RE: Starbucks and T-Mobile
Lot 3B and 4A Krania Subdivision
Grading and Drainage Plan
Engineer's Stamp Date 3-9-2017 (File: K09D031C)

RE: Starbucks and T-Mobile
Lot 3B and 4A Krania Subdivision
Grading and Drainage Plan
Engineer's Stamp Date 2-23-2017 (File: K09D031C)

**RE: Revised Grading Plan (K09-D031C)
Starbucks and t-mobile
Albuquerque, New Mexico**

**Re: STRABUCKS and T-MOBILE
Lot 3B and 4A KRANIA SUBDIVISION
Grading and Drainage Plan
Engineer's Stamp Date 12/12/16 (K09/D031C)**

Plat of
Lots 1, 2, 3, 4, 5, and 6

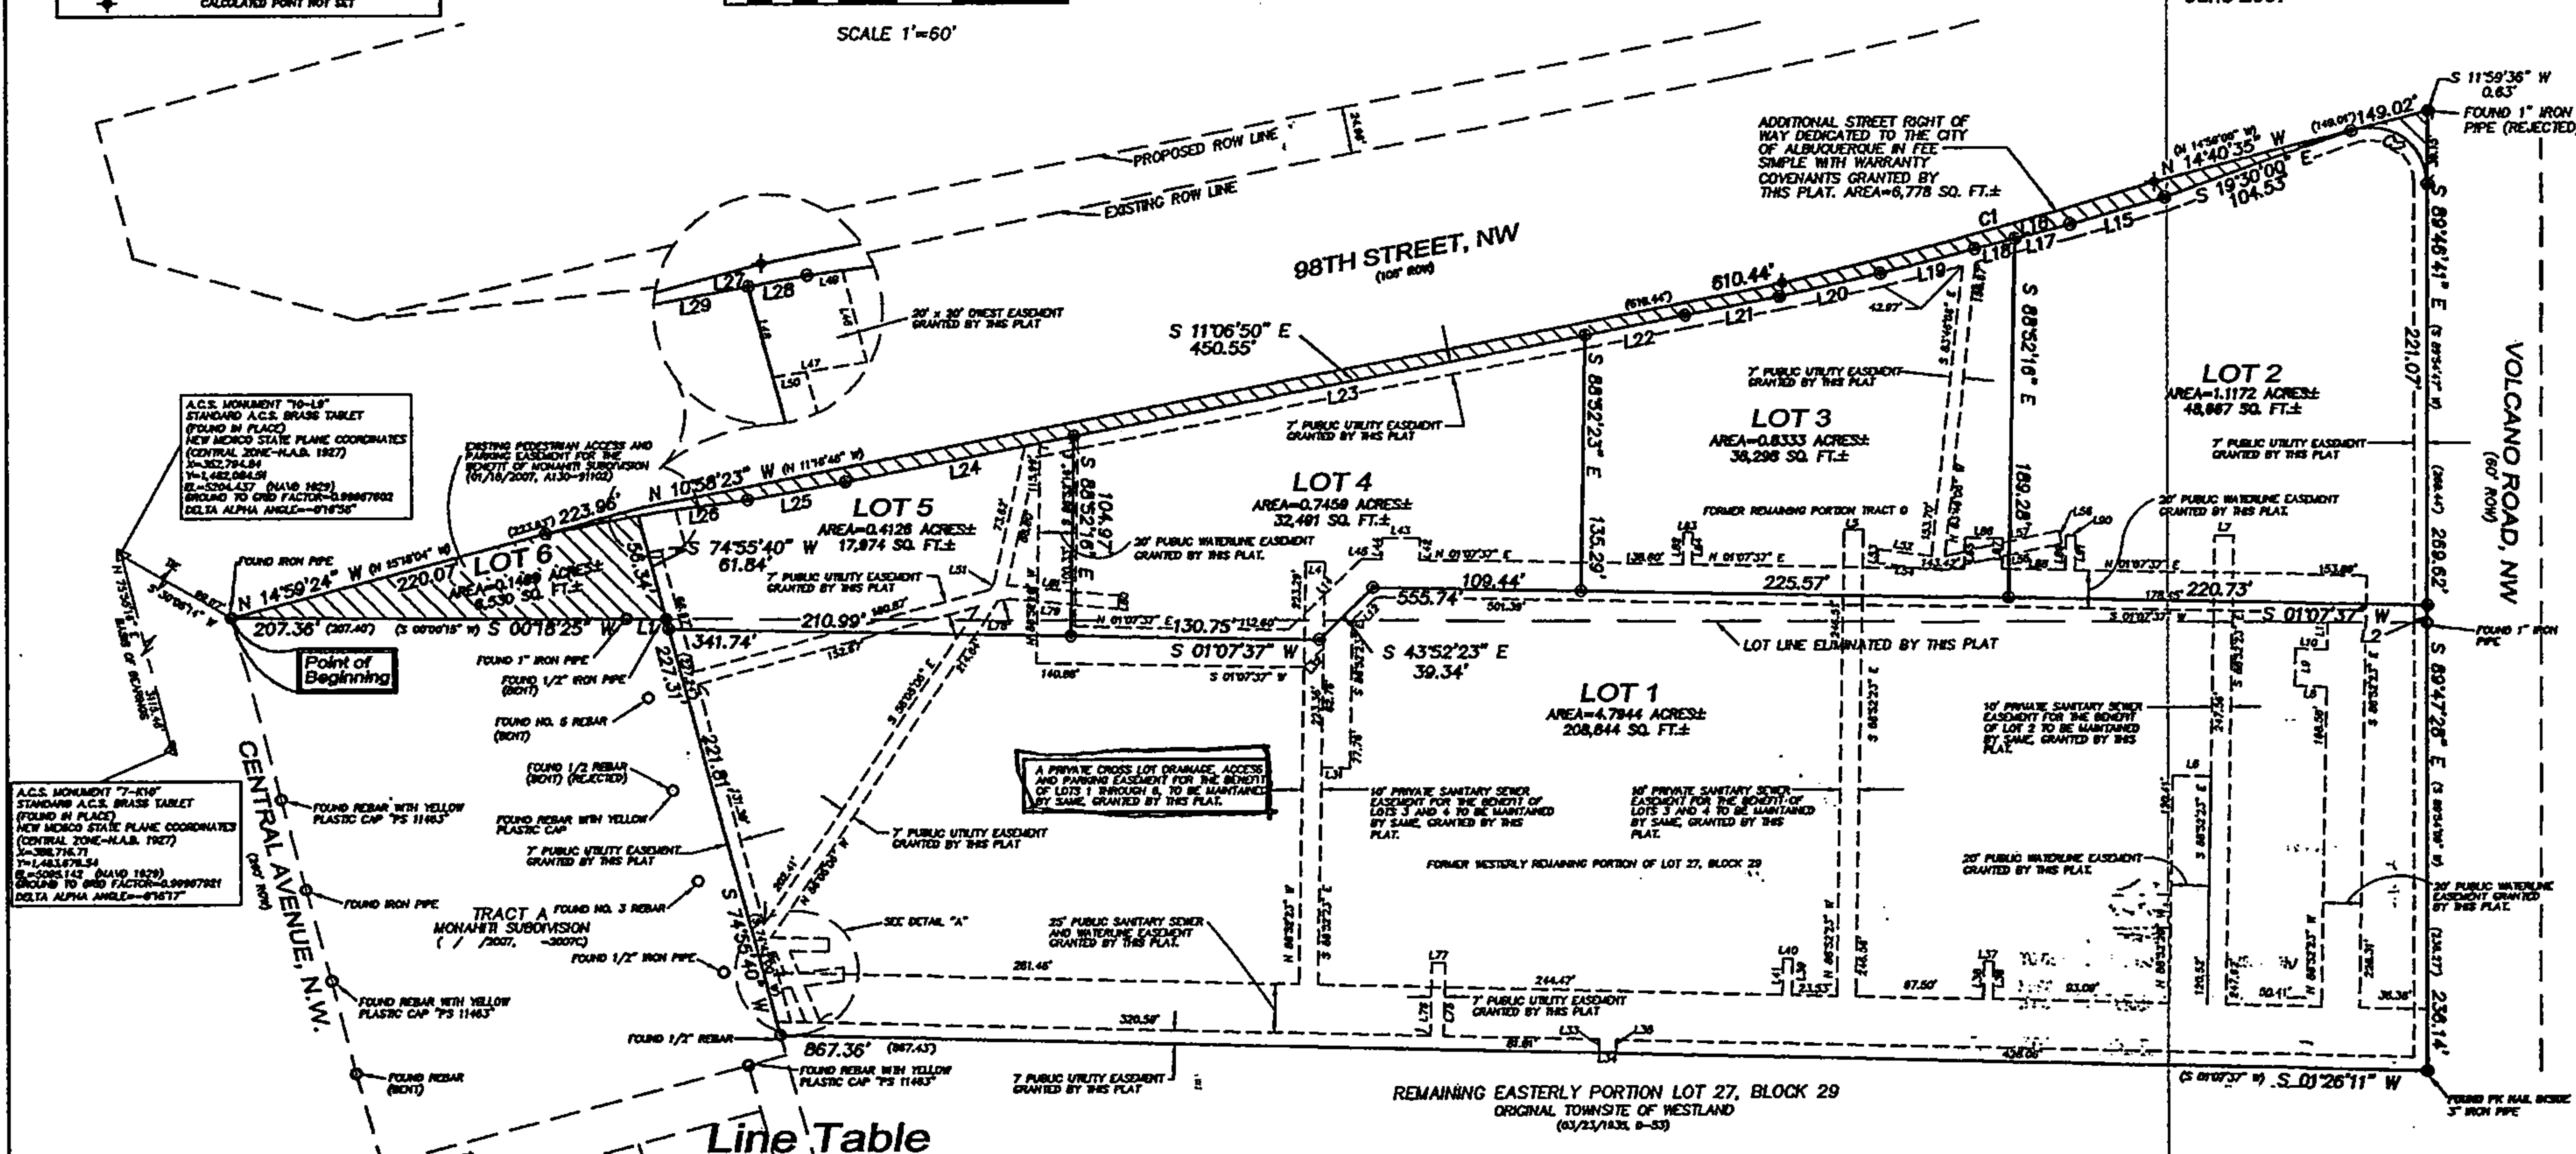
3. Provide Cross access and drainage easement.

We placed a red box around the verbiage on the plat dedicating the drainage easement. The placement of the note adjacent to dimension leaders for the sewer easement are confusing, but the lots have cross lot drainage, access and parking as shown on plat.

A PRIVATE CROSS LOT DRAINAGE, ACCESS
AND PARKING EASEMENT FOR THE BENEFIT
OF LOTS 1 THROUGH 6, TO BE MAINTAINED
BY SAME, GRANTED BY THIS PLAT.
